TAL-CO SUPPLEMENTAL INSTRUCTION #89			
Test Facility - Rolling Door Jamb Detail			
Project Name:	RW TOMLINSON - NEW HEAD OFFICE		
Project Location:	100 CitiGate Drive, Ottawa, Ontario		
ARCH. SI #:	ASK-241	Issued By:	Farah Bano
STRUC. SI #:	N/A	Date Issued:	March 7, 2018
MECH. SI #:	N/A	Revision #:	N/A
ELEC. SI #:	N/A	Revision Date:	N/A

TITLE: Test Facility - Rolling Door Jamb Detail

PROJECT:
TOMLINSON NEW BUILDING

ASK-241

ROLLING DOOR JAMB DETAIL

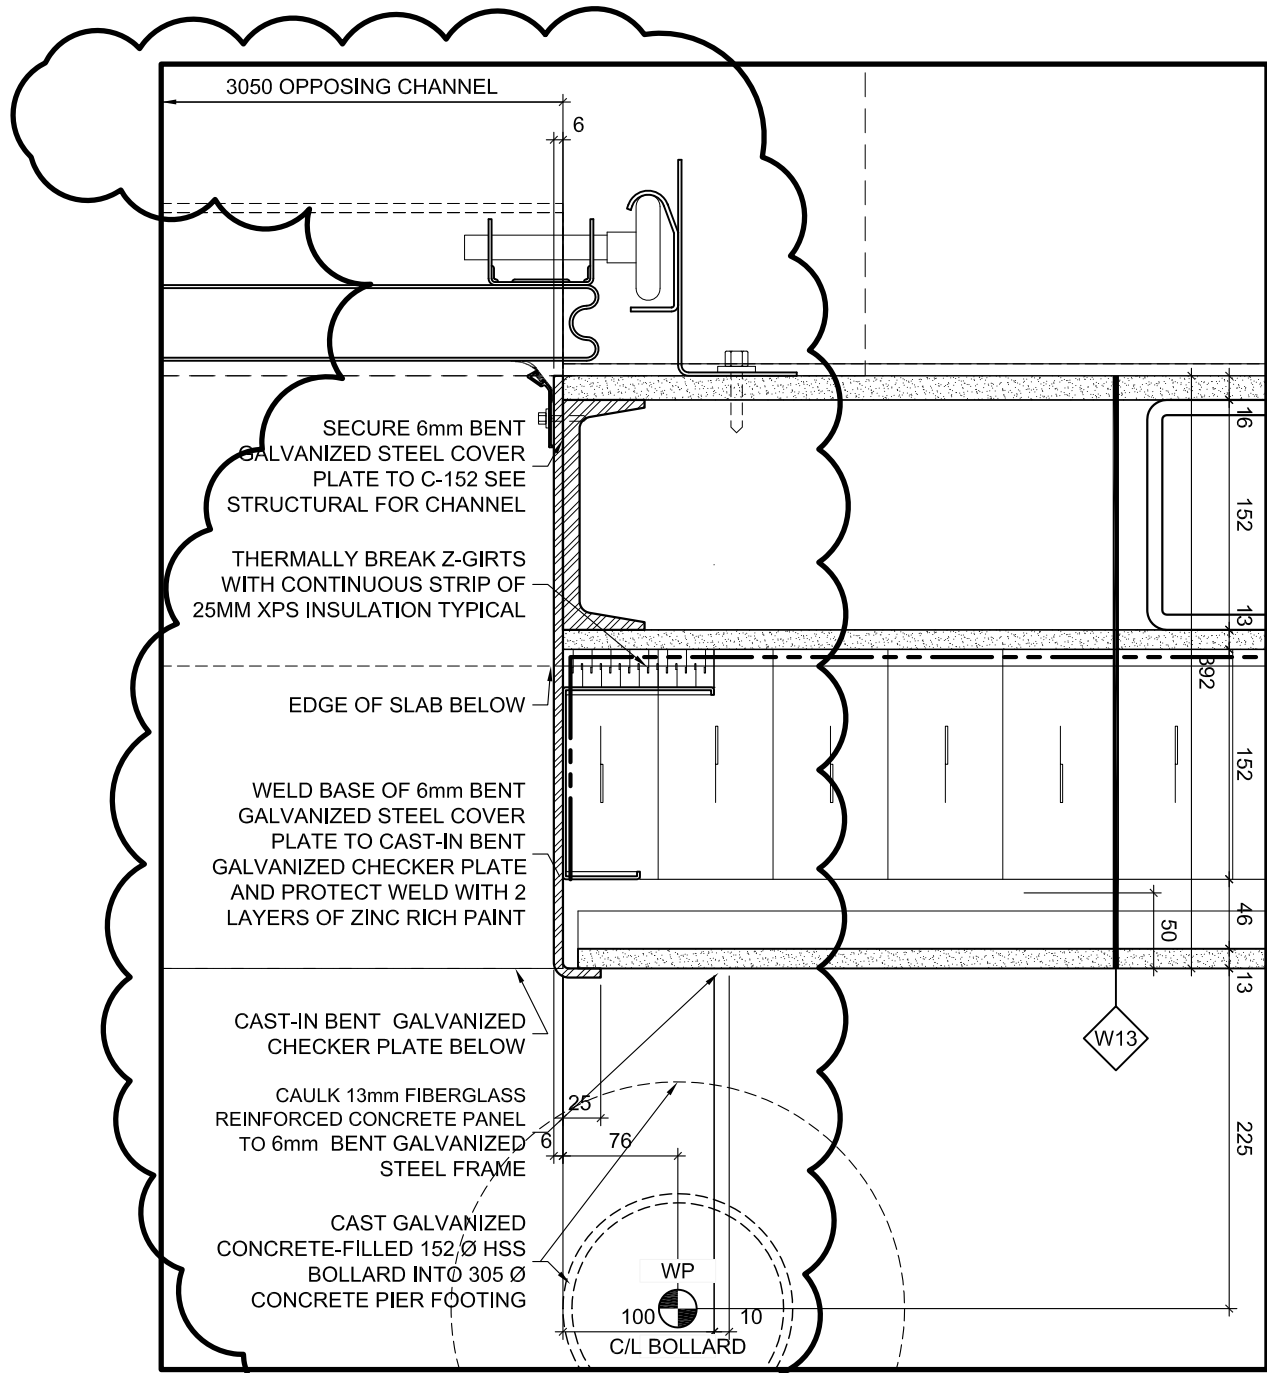
Alternate detail provided for install of the overhead doors to provide protection from impact

Overhead doors were not installed with 6mm galvanized bent steel cover plates as detailed
